# Product Change Notification

Product Change Notification: E-20-010042

DEUTSCH DRB Wedges Material Change

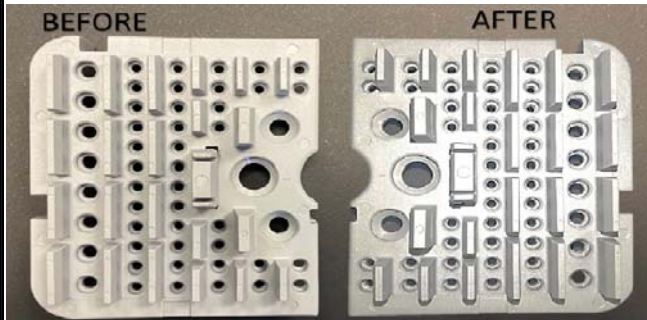
The Industrial and Commercial Transportation business unit of TE Connectivity is making a material change to the DRB wedge locks resin for the part numbers listed below. PPAP and/or sample requests must be submitted within 14 days of PCN submission via ict-ppap-request@te.com or ePPAP system. Submission will not occur without request. If PPAP requested, disposition response is required within 14 days of submit date or it will be considered approved. Product drawings are not affected.

Product Improvement. Dear Customer, we hereby inform you of this change as part of our aggressive continuous improvement efforts. The flammability rating on the newly approved wedge lock material is V-0 while the current one is HB. The current and the new raw materials are PBT 30G, therefore the change does not impact performance nor fit, form and function. IMPORTANT: The current and previous revisions of these parts can be used interchangeably in the field. The change is being phased in gradually and previous revision can remain stocked until use. Shipments of both configurations may be mixed.
